DEVELOPMENT APPLICATION ASSESSMENT REPORT

Application Number:	DA2024/0004
----------------------------	-------------

Responsible Officer:	Anais Sarkissian
Land to be developed (Address):	Lot 22 DP 7022, 31 Kooloorra Avenue FRESHWATER NSW 2096
Proposed Development:	Demolition works and construction of a dwelling house including swimming pool
Zoning:	Warringah LEP2011 - Land zoned R2 Low Density Residential
Development Permissible:	Yes
Existing Use Rights:	No
Consent Authority:	Northern Beaches Council
Land and Environment Court Action:	No
Owner:	Hsiu-Hui Hsu Christopher James Hudson
Applicant:	Christopher James Hudson

Fig 5: North-western elevation - original design

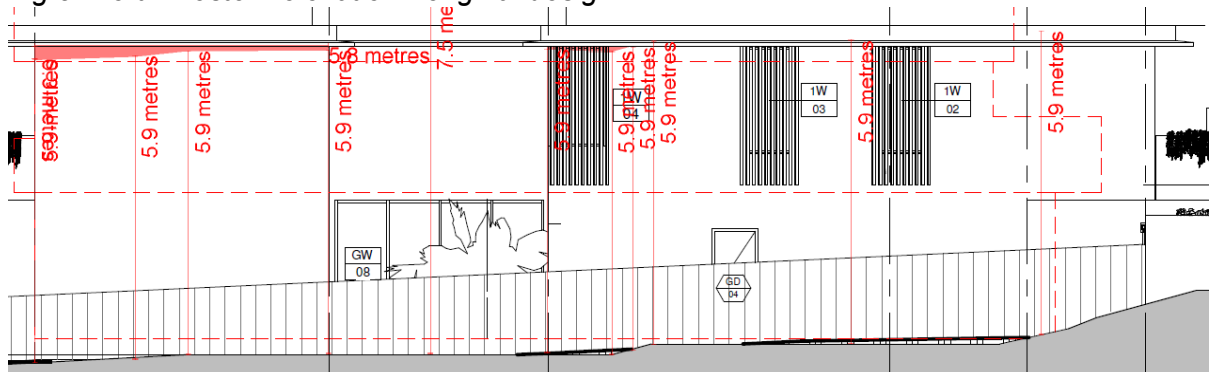
Concern was raised that the building in many areas is outside the building envelope and suggested the design be modified such that the building is totally within the building envelope.

It is evident from the red shading that only a small portion of the north-western elevation is outside the building envelope, and it is noted that at this point of the building, the setback is compliant and there are no windows.

Fig 6: North-western elevation - amended design

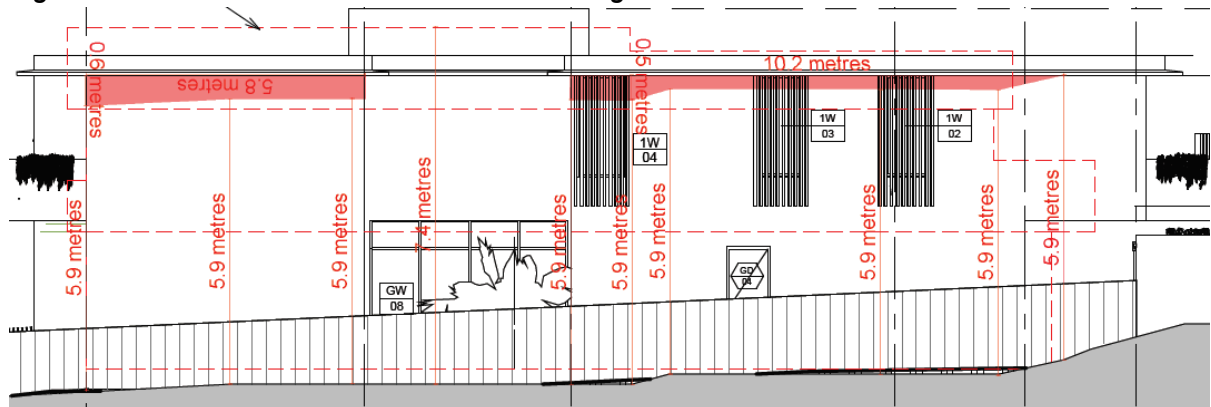
The development was amended and it is noted that the need to raise the building 390mm to satisfy the flood engineer's requirements meant that the building envelope encroachment also increased, notwithstanding no change in side setbacks. The building does not breach the envelope at any other point. Building envelope is assessed in further detail under Section B3.

Fig 7: North elevation showing proposed dwelling in the context of existing dwelling and #29

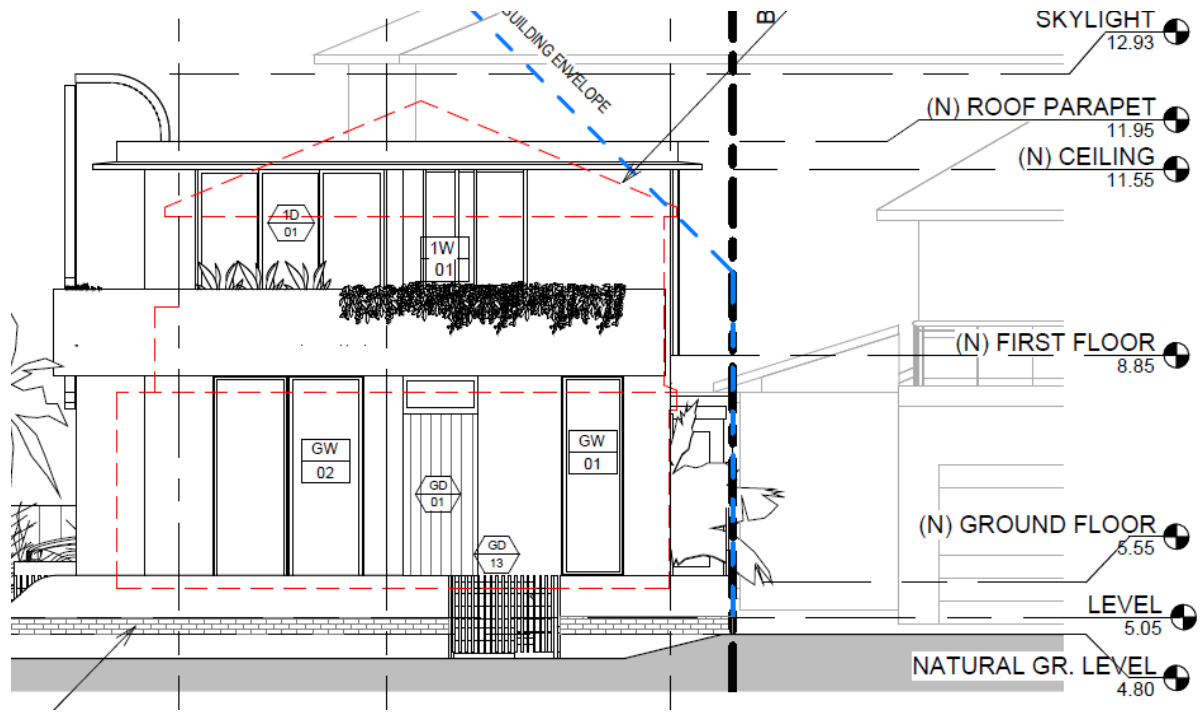
The submissions raised concerns that the roof line, blade wall and first-floor balcony at the Kooloora Avenue entry exceed the required setback of 6.5m from Kooloora Avenue, and that this will block views from adjoining properties.

As evident from Figures 1-4 above, the amended design considerably reduces the protrusion of the roof and blade wall into the front setback area. The roof is not considered to block views, particularly given its raised height and flat design, as the ceiling height is higher than that existing and effectively opens up the view corridor for the adjacent neighbour (refer Figure 7 below, with the outline of the existing dwelling shown dashed red). A condition has been included within this consent to amend the design such that the blade wall at the first floor be removed and replaced with a 250mm x 250mm (max.) structural column. This further opens up the balcony and allows for views to be enjoyed from the adjoining property out to the ocean towards the ENE, east and ESE. It is important to note that the main building line at the first floor is set back a compliant 6.5m from the primary frontage to Kooloora Avenue, which is not dissimilar to the setback of the existing dwelling at 6.6m. With the removal of the blade wall, the only protrusion of the proposal into the front setback area at the first floor is the balcony, which is an unenclosed structure that is not parallel to the building line (refer Figure 8); the building at this level is otherwise compliant. The existing view corridor to #29 is thereby largely maintained, while minimising the trafficable area of the balcony, and thus privacy and overlooking impacts. In this way, regardless of the presence of the balcony, the view corridor is maintained to the entire front setback area. As such, the impact of view loss is not considered to be nominal.

Fig 9: Shadow diagrams

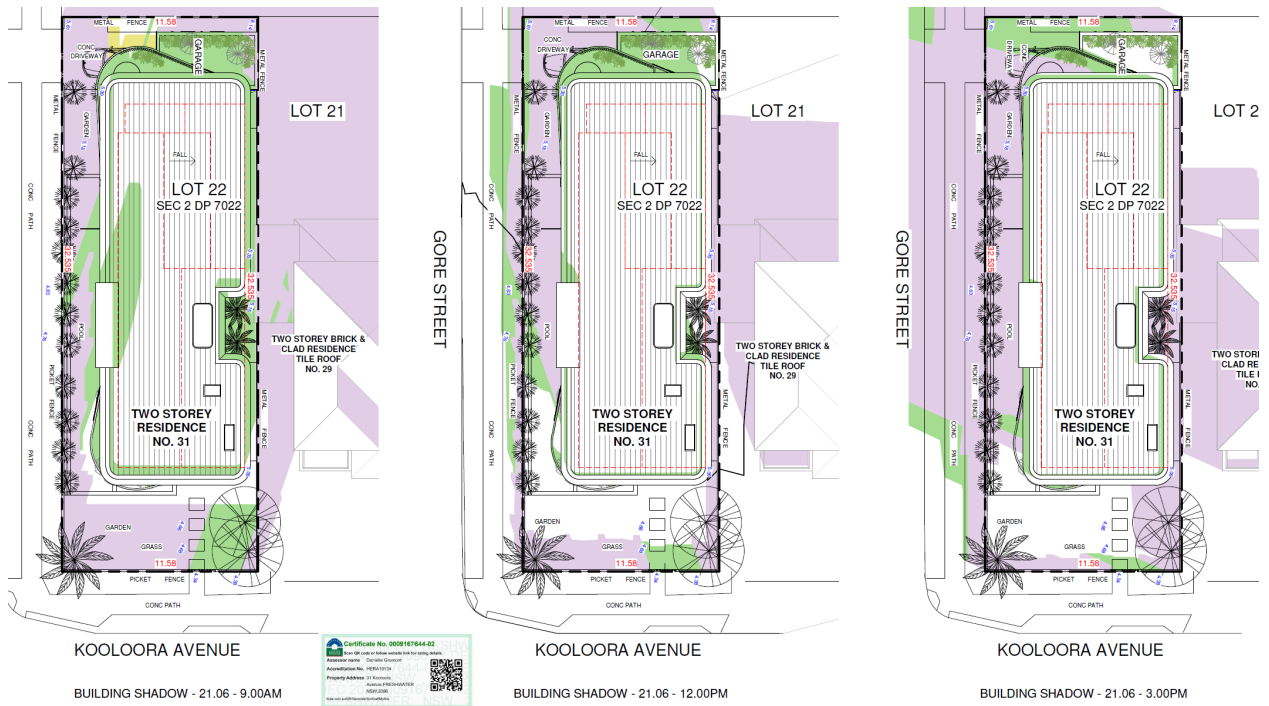
The submissions raised concerns that the large increased size of the building will result in significantly increased shadowing of adjoining properties.

The shadow diagrams submitted with the application demonstrate that the proposal results in no additional overshadowing to adjoining properties, with the existing shadows cast by the current dwelling shown shaded purple and the additional overshadowing created by the proposal shown shaded green (refer Figure 9 below).

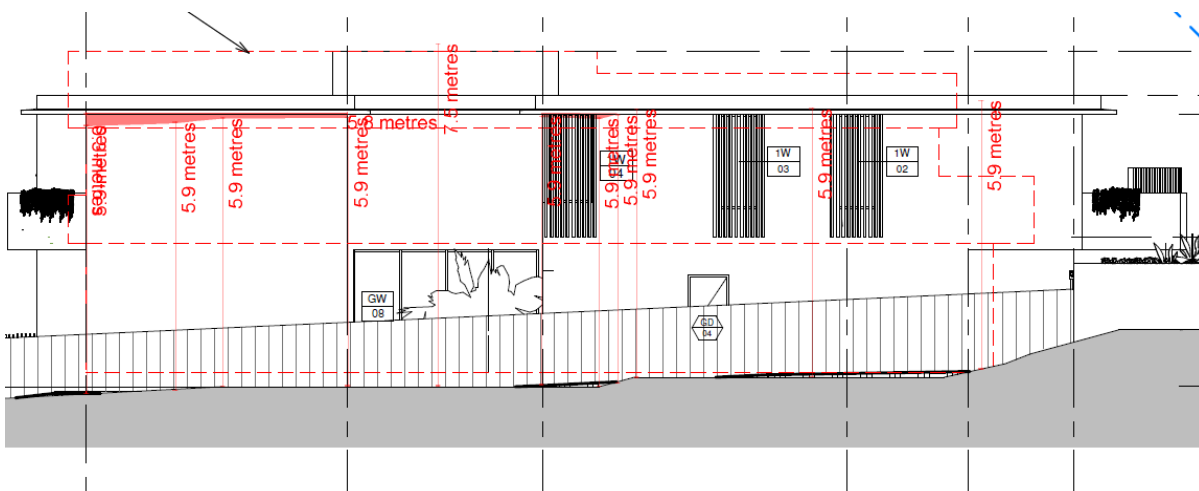
The proposed dwelling presents an encroachment at the north-western elevation of 0.6m in vertical height for a horizontal length of 5.8m, and 0.5m in vertical height for a horizontal length of 10.2m, representing a maximum variation of 10.2% (0.6m), as shown shaded red in the figure below.

It is important to note that this envelope breach is largely a result of the need to increase the height of the floor levels and overall building height by 390mm to accommodate the flood engineer's requirements. The initial amended design had a negligible envelope breach of 5.1% (0.3m), as indicated in red below. It is also important to note that the proposal is compliant with the minimum side setback requirement of 0.9m. Furthermore, the only windows on the north-western elevation at the first floor are to the ensuite and study, and these are to be screened, as shown below, therefore not impacting on the privacy of the neighbouring dwelling.

Original design ground and first floor plan

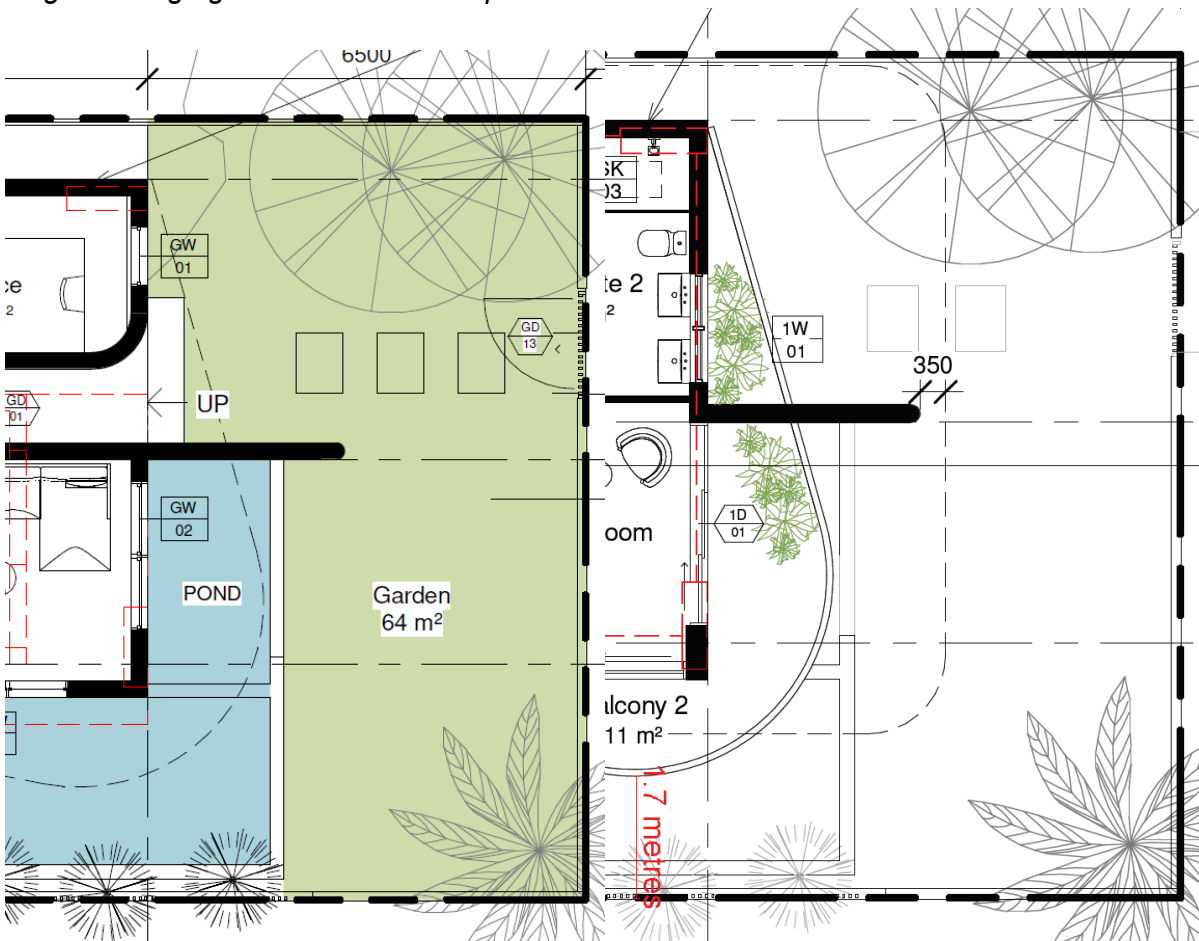
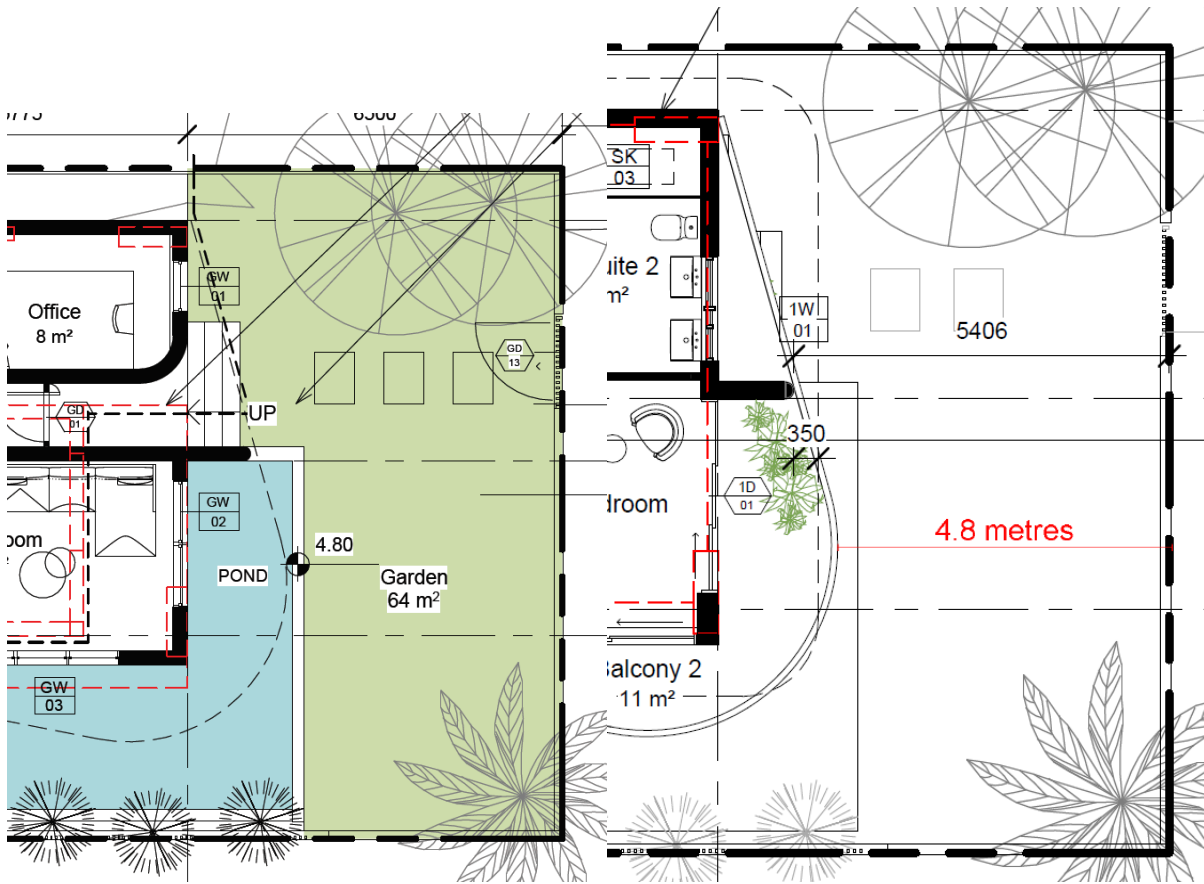
The proposed pond coping is setback 4.5m from Kooloora Avenue, the balcony on the first floor protrudes 1.7m into the front setback area, and the blade wall has a 5.4m front setback, presenting a maximum variation of 30.8% (2m) to the 6.5m minimum standard. However, the main building line is 6.5m from the front boundary.

It is important to note that the blade wall was originally 3.6m from the front boundary, and has therefore been taken in by 1.8m with the amended design. The roof has also been brought back from the front boundary considerably, as evident in the plan extracts below. Furthermore, the balcony is not parallel to the front building line and therefore protrudes less into the front setback area towards the north-west of the dwelling.

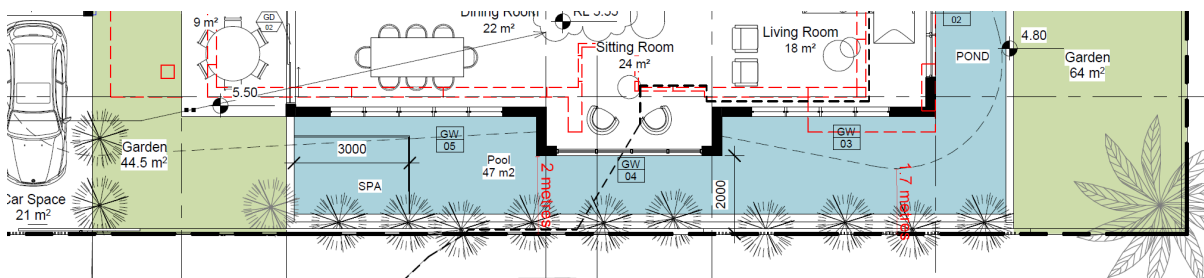
The proposed pool coping has a nil setback from the secondary street frontage to Gore Street, and the first floor balcony has a 1.7m setback. The main building line is setback 2m from Gore Street, however, this is the skylight/void portion of the built form; the bulk of the building line to Gore Street is 3m from the boundary, as evident in the plan extract below. Additionally, the site does not directly face any other dwellings on this side, interfacing a public park and Freshwater Beach.
